September 26, 2019

Planning Team Leader  
Forest Plan Revision  
Pacific Southwest Region  
USDA Forest Service

**Re: Comments on the Sequoia and Sierra National Forests Land Management Plans  
Revision #3375**

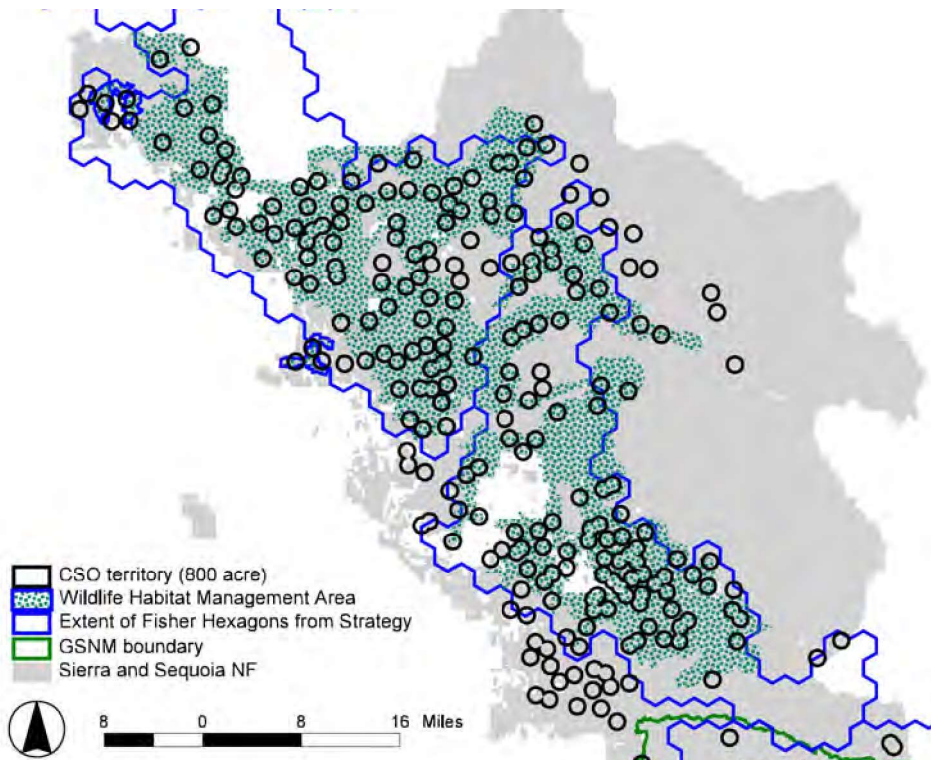
There are two points of divergence for Alternative B from the fisher conservation strategy – where the diameter limit applies and what the diameter limit is. First, Alternative B adopts a 30 inch tree diameter limit within spotted owl territories and allows exceptions for the removal of trees up to 40 inches in diameter outside of territories. We examined the potential cumulative footprint the territories that would be delineated in Alternative B using the spotted owl data base maintained by California Department of Fish and Wildlife. There were 312 activity centers in this database that occurred within the boundaries of these two national forests and outside the boundary for the Giant Sequoia National Monument. The total area encompassed by a circular territory of 800 acres centered on an activity center was just over 270,000 acres. To evaluate the extent of the area outside of the spotted owl territories that might be utilized by fisher, we compared this footprint of the spotted owl territories with the Wildlife Habitat Management Area included in Alternative B and the extent of fisher hexagons used in the fisher conservation strategy (Figure 1).

We found that a significant portion of area occupied by fishers is outside of the spotted owl territories. These areas would be available for the harvest of trees up to 40 inches in diameter to reduce stand density and create openings. This conflicts with the recommendation in the fisher conservation strategy to limit the removal of trees over than 27 inches within the fisher hexagons (see Figure 1).

The second point of departure of Alternative B from the fisher conservation strategy is the diameter limit itself. The fisher strategy recommends a limit of 30 inches for mixed conifer species generally, and a 27 inches limit for pines species. These values are derived from den and rest sites used by fishers. Alternative B provides no direction about retaining pines from 27 to 30 inches and allows removal of all species up to 40 inches diameter outside of territories.

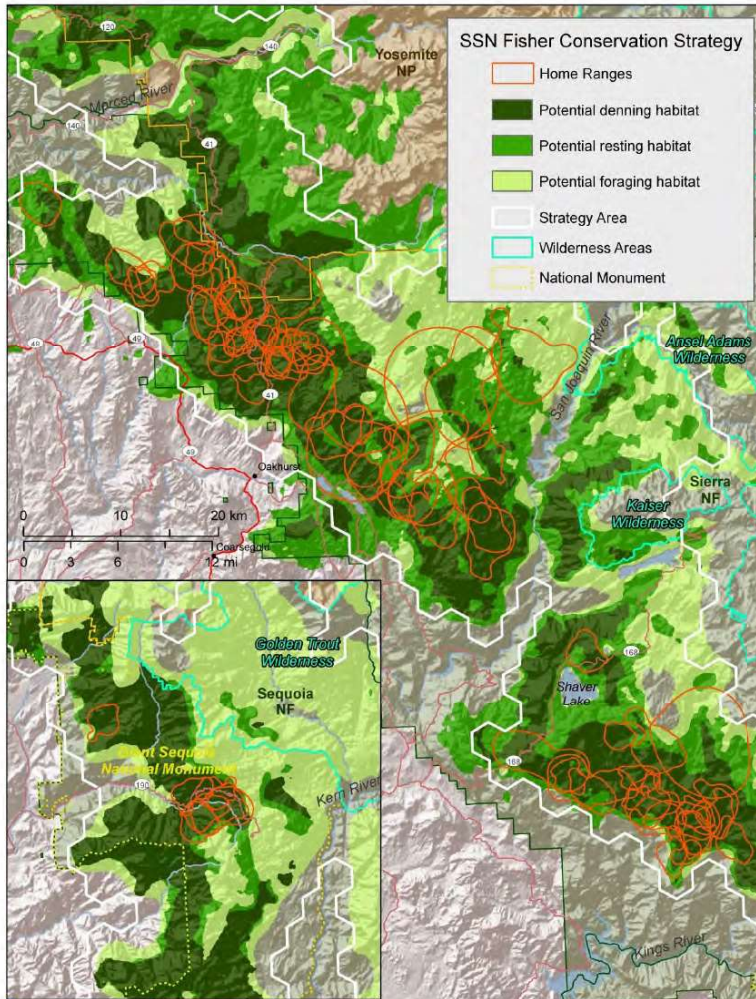
The area where trees up to 40 inches could be removed can also be compared to the habitat maps contained in the fisher strategy (Figure 2).

Using the hexagon boundary (Figure 1) and Strategy Area (Figure 2) as points of reference, it can be seen that significant area identified as potential denning and resting habitat occurs outside of the spotted owl territories. Logging of trees up to 40 inches in diameter would be allowed in these areas and is contrary to the recommendations of fisher experts.

Map 1. Showing range of the *B. altasierrae* on the Sequoia National forest and the level 1, 2, 3 and 4 roads which are being cleared of hazard trees in preparation for reforestation.

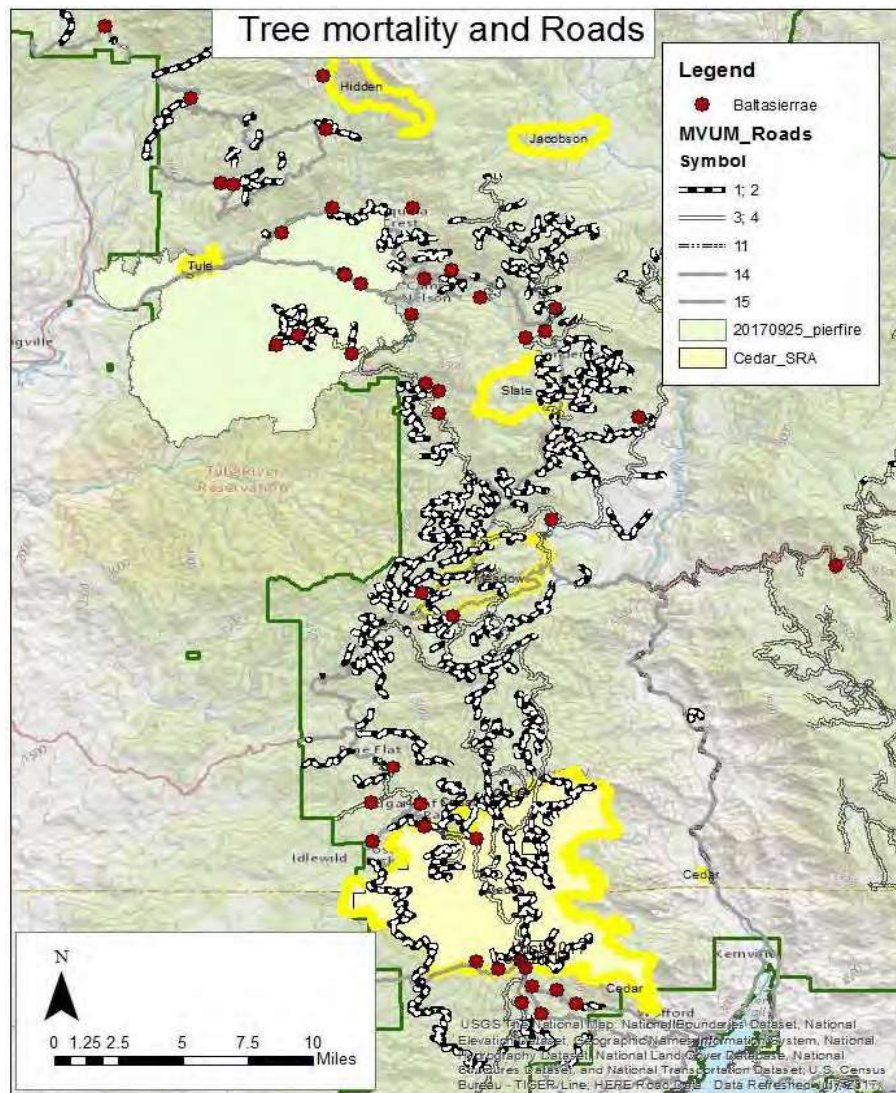
Between 2014 and 2017 over a 50 % decline in trees per hectare occurred due to drought and insect-related mortality across the Sequoia National Forest and in the Greenhorn Mountains (Fettig et al. 2019). This involved declines in pines trees of over 67 % (Fettig et al. 2019). With pine mortality comes the loss of pine duff and loss of shade making forested ground habitats warmer and drier. Much of this mortality was in the Greenhorn Mountains where slender salamanders occur. For slender salamanders that use pine duff; the loss of pine trees is critical because this habitat component protects them from desiccation and predators, as well as providing food. Effects on *B. altasierrae* are compounded by the need to remove hazard tree from a 300 foot buffer alongside roads over much of the range for *B. altasierrae* (see map 1).

Since recent surveys of all suitable habitat have not been conducted, mechanical incursions into the high elevation draws and ephemeral streams can crush salamanders residing in these areas.
